ENGINEERING-GEOLOGIC ASSESSMENT OF THE PROPOSED HATCHER PASS SKI RESORT AT
GOVERNMENT PEAK, SOUTHCENTRAL ALASKA

R.A. Combellick and R.D. Reger

October, 1988

Figure 2.— Geologic map of the proposed Hatcher Pass ski resort. Geologic units are described in Table 1. Coarse stippled pattern indicates where bedrock is shallow (less than about 10 ft). Areas proposed for development are also indicated (see fig. 1).

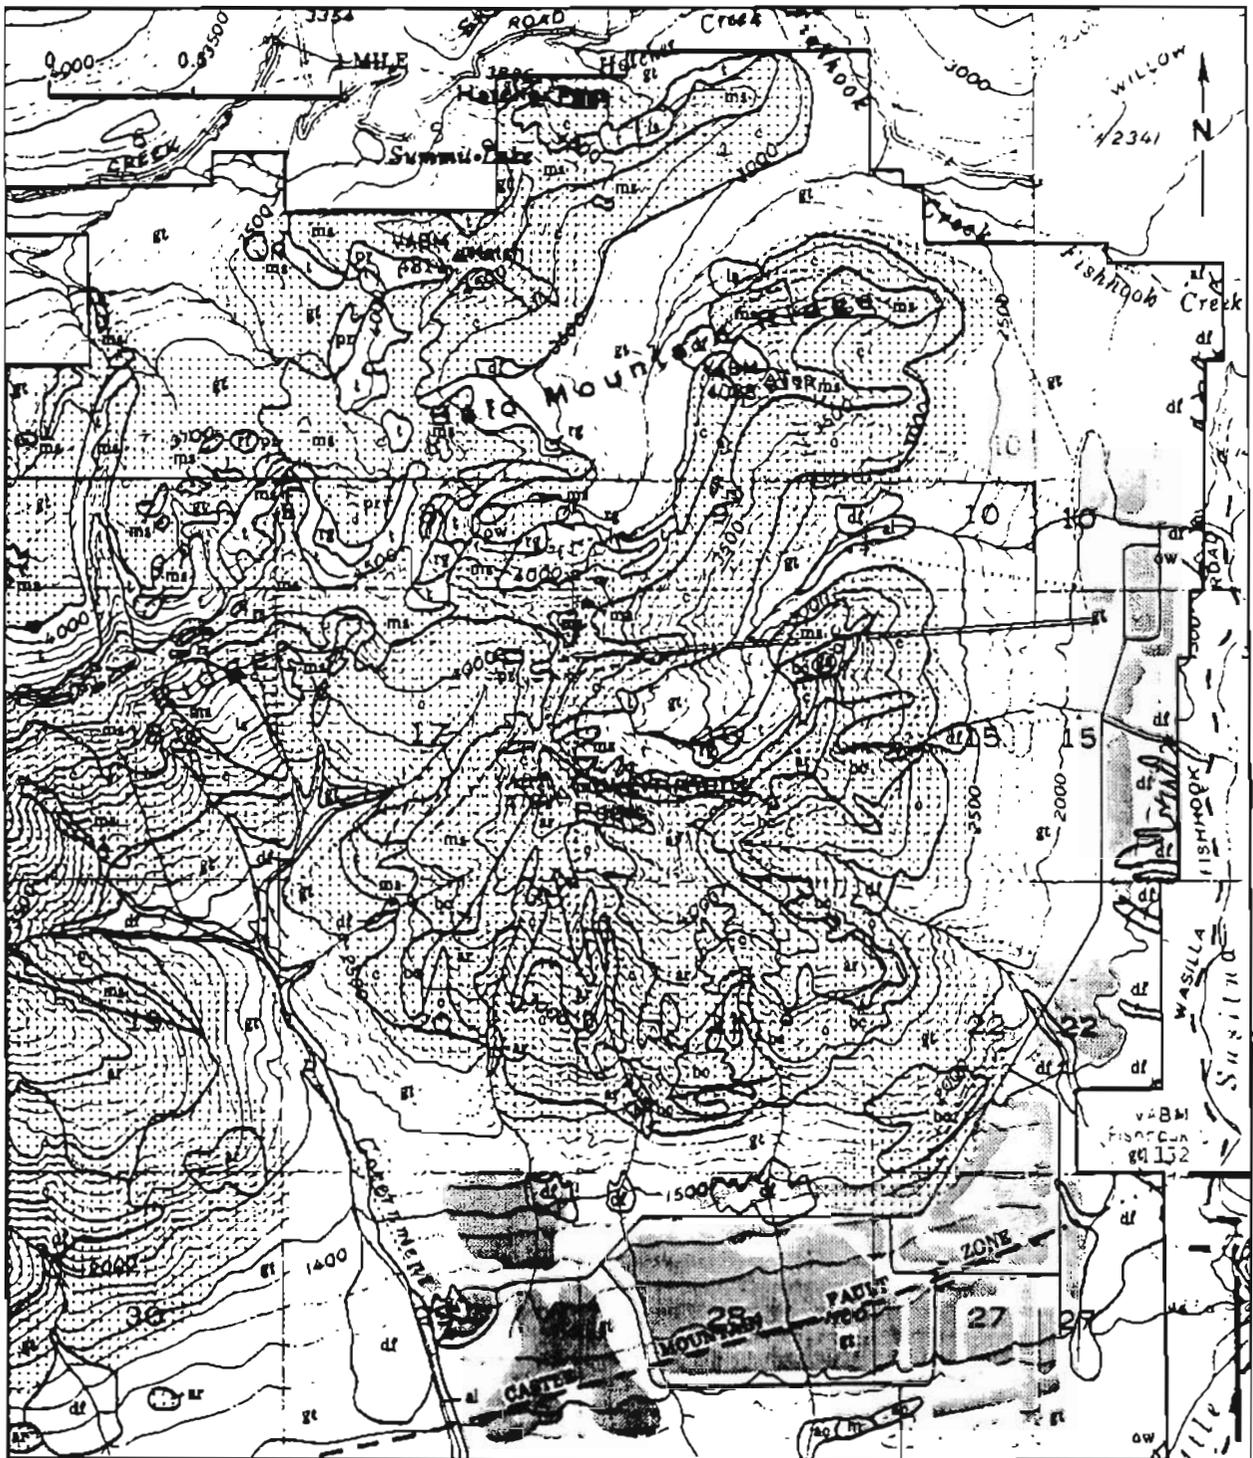
The proposed locations for most facilities in the base areas of the ski resort are on glacial till (fig. 2). This deposit contains varying proportions of gravel, sand, and silt, including local concentrations of large boulders. In its natural state, the till is generally very dense and firm below a looser surface layer of peat, silt, and sandy till that ranges from about 1 to 6 ft thick. Its bearing capacity is therefore high and well suited as foundation material for large structures. If the till on or near steep slopes becomes saturated, however, it can be subject to flow failure (see Erosion and Debris Flows).

In addition to debris flows, there are two other types of landslides in the area. Debris slides (ls) were identified in three places (figs. 2 and 3). The two small slides in the northern part of the area are probably inactive, although they would not be good sites for permanent structures because of possible renewed activity. A large debris slide in the headwater area of Government Creek is probably still active. Present movement is probably by creep, although a major rapid failure is possible. No permanent structures should be built on or below this slide.

The Castle Mountain fault zone, which passes through the southern part of the area (figs. 2 and 3) is probably more likely to cause damage to structures in the proposed ski area than earthquakes along the subduction zone. The term 'fault zone' is used because the Castle Mountain fault has no single well-defined plane of displacement in this area. Rather, it is a zone of fault planes that may be several hundred feet wide. Geologic and seismologic evidence shows that this fault is active. A scarp more than 6 ft high along the fault between Houston and the Susitna River marks an area where the fault has displaced recent alluvium, and a magnitude 5.2 earthquake near Sutton in 1984 was directly attributed to slip on the fault.

3. Although all structures are vulnerable to damage if built on an active fault, residential buildings specifically should not be constructed on or adjacent to the Castle Mountain fault zone. The State of Alaska has no requirement for minimum setback from active faults, but California requires that structures for human occupancy be no closer than 50 ft from an active fault. This should be considered a minimum guideline. To locate fault planes, a geologist with experience in fault studies should conduct detailed surficial mapping and trenching surveys across the fault zone. If structures are located at least $\frac{1}{4}$ mile from the mapped fault zone (figs. 2 and 3), there should be no need for detailed fault studies.

4. In the event permanent structures are proposed on or near the smaller fault zones around Government Peak (figs. 2 and 3), field studies should be conducted to accurately map their locations and to determine the probable age of most recent activity.

Figure 3.— Geologic constraints to development in the proposed Hatcher Pass ski area (legend on following page).

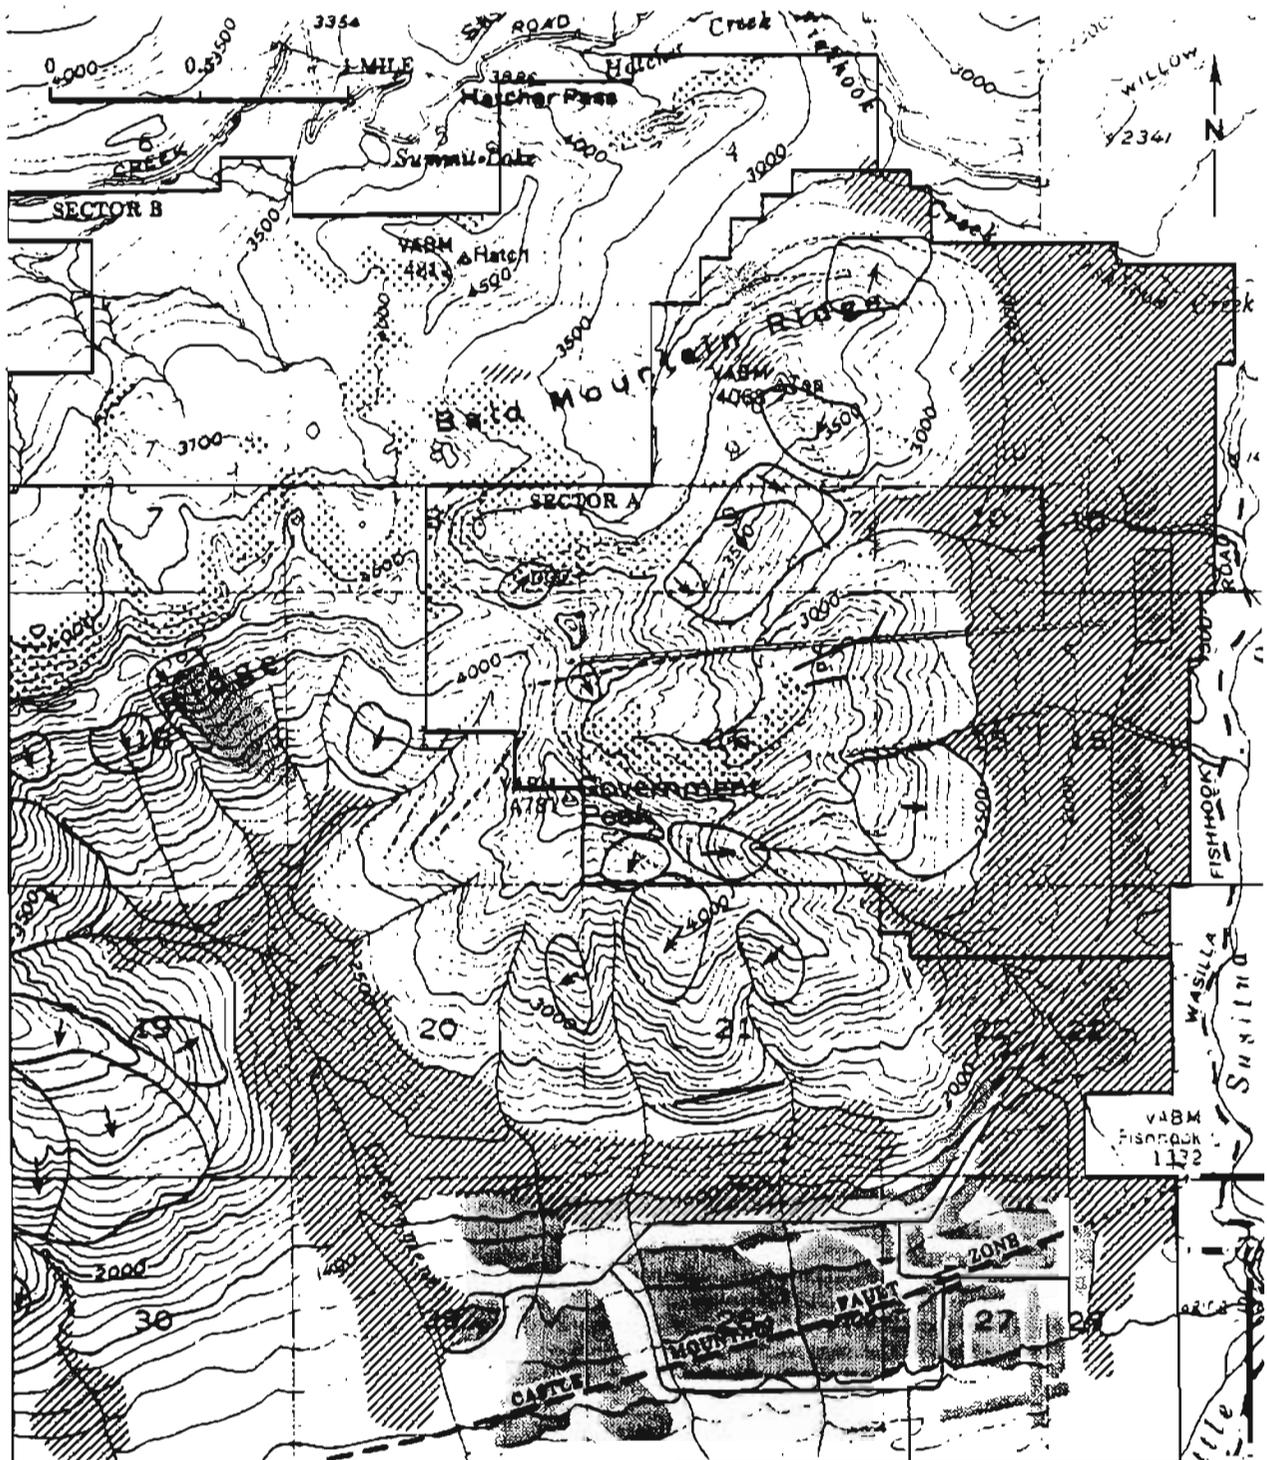
Areas that are susceptible to gullying and debris-flows, based on evidence of where these processes have occurred in the past, are shown in Figure 3. Development activities in these areas that could increase the likelihood that gullying and debris flows become a hazard to facilities and public safety include:

2. Remove as little vegetation as possible within areas prone to erosion and debris flows (fig. 3) and revegetate excavated slopes where possible. On ski slopes, maintain as much ground vegetation as is consistent with the primary use of the slopes. Small debris flows may be a persistent minor maintenance problem on the ski slopes.

1. Perform a slope-stability analysis wherever permanent structures will be located on till slopes to ensure that the slope after construction will have a safety factor of at least 1.5.

3. Install carefully engineered diversion ditches and interceptor drains to divert drainage around structures and away from disturbed surfaces and unstable slopes into existing channels.

Figure 4.— Snow-avalanche potential in the proposed Hatcher Pass ski area. H—high potential, M—moderate potential, L—low potential. Areas proposed for development are also shown (see fig. 1). (Figure by G.D. March)

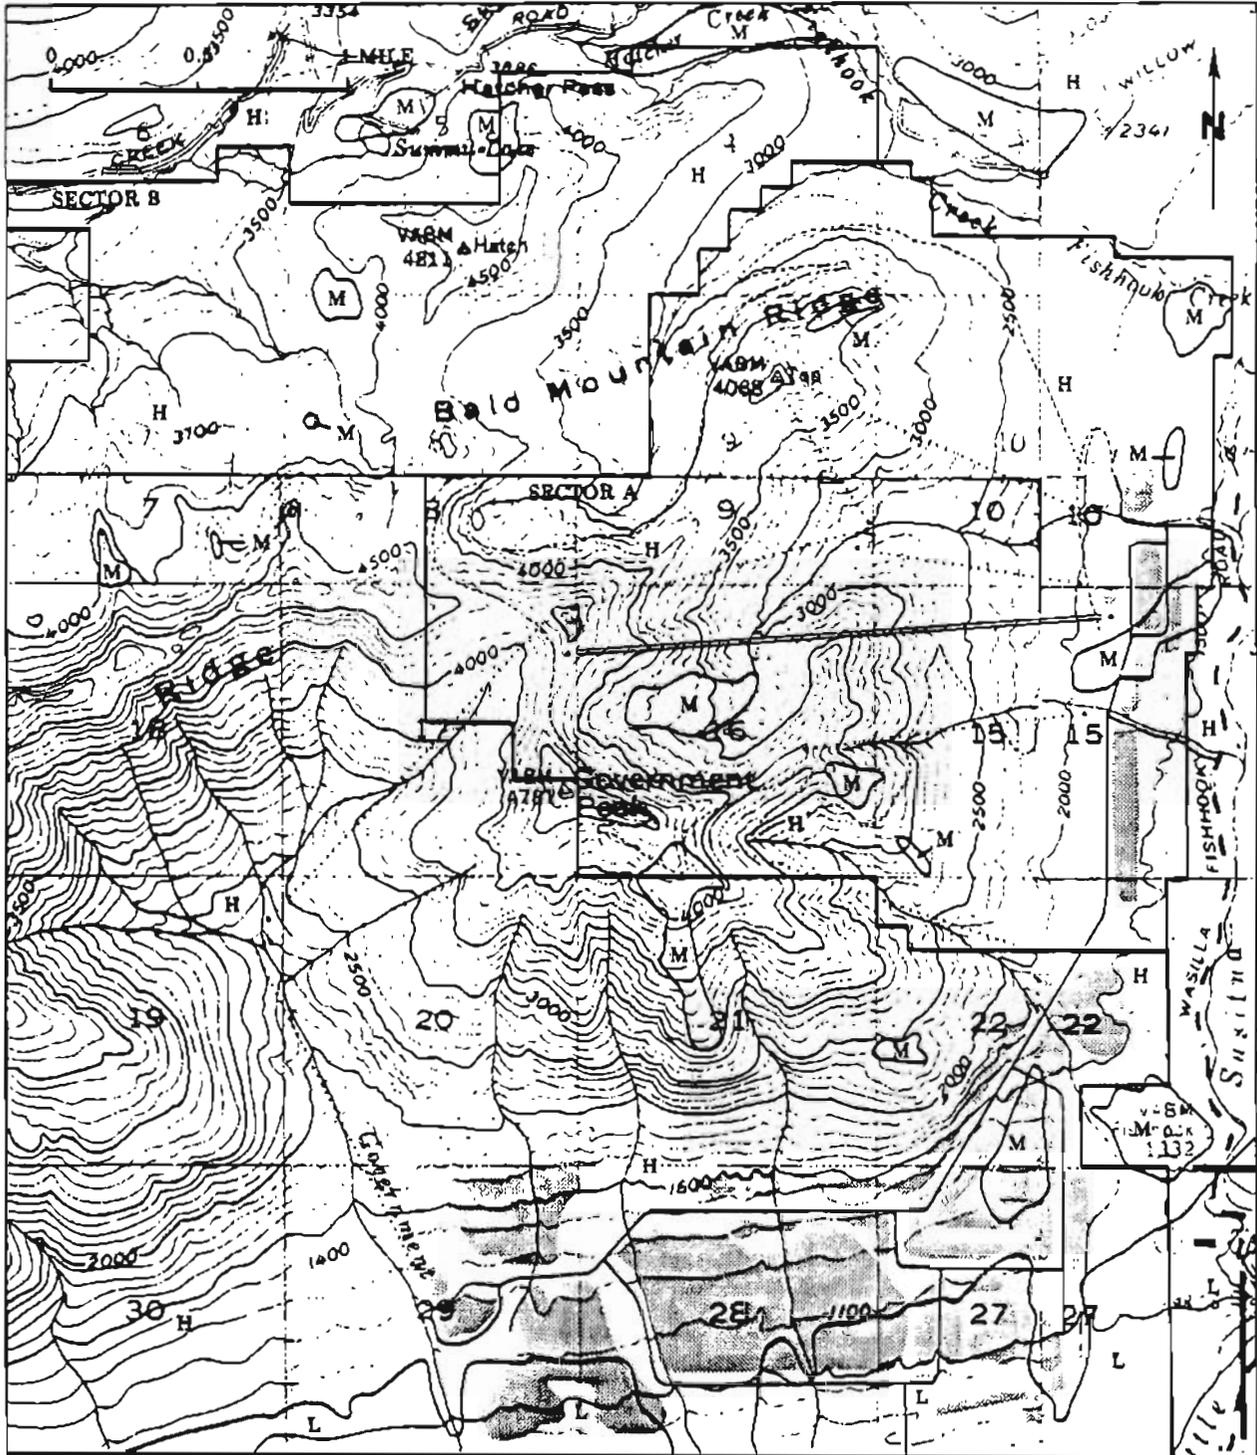
Interpretation of aerial photographs and prior knowledge of the area indicates that snow-avalanche potential is moderate to high in nearly all areas above about 1,100 ft (fig. 4). The proposed ski area places structures at the bottoms of slopes with high avalanche potential, especially on the eastern side of the area.

1. Building sites should be examined in detail by trained personnel to ensure that they will be safe from 100-year snow avalanches, as one of these could happen in any year. Examination should occur both winter and summer before construction begins.
2. 'Designation of Special Use Lands, Hatcher Pass Management Unit, Addendum A to Document of Intent, date November 21, 1986' states that a snow-safety plan will be required for winter commercial operations. Backcountry skiing operations are specifically listed, but downhill ski areas are not. This document should be updated to include the proposed downhill ski area, and a snow-safety plan should then be required.
